Bulletin No.: PI1264

# PRELIMINARY INFORMATION

Subject: Accessory Fog Lamp Kit Inoperative

Models: 2014-2015 Chevrolet Equinox

3942260

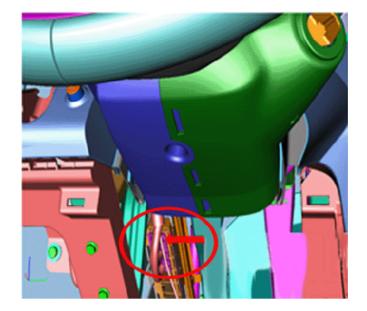
- 2.1. Visually inspect the I/P Harness part number tag on the Harness per below (I/P harness part number tag located between ground 207 and body inline connector):
  - 2014 MY Harness Part Numbers # 23164353; 23164354 and 23181681 requires an added circuit.
  - 2015 MY Harness Part Numbers # 23235768; 23235769 and 23235770 requires an added circuit.

3942263

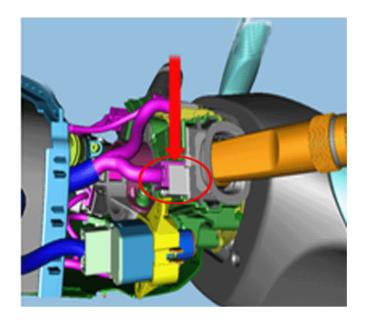
2.2. Visually inspect the I/P Harness BCM Connector 19151262 Cavity 14.

- (1) JST Terminal: SNAC3-A031T-M0.64. Crimp and solder terminal to wire
- (2) 0.80 (18 ga) TXL
- (3) 1000.0 mm (39.4 in)
- 3. If circuit 192 is missing, create the above circuit.
  - Wire size can be from 0.35 to recommended 0.80.
  - Wire insulation type can be TWP or recommended TXL.
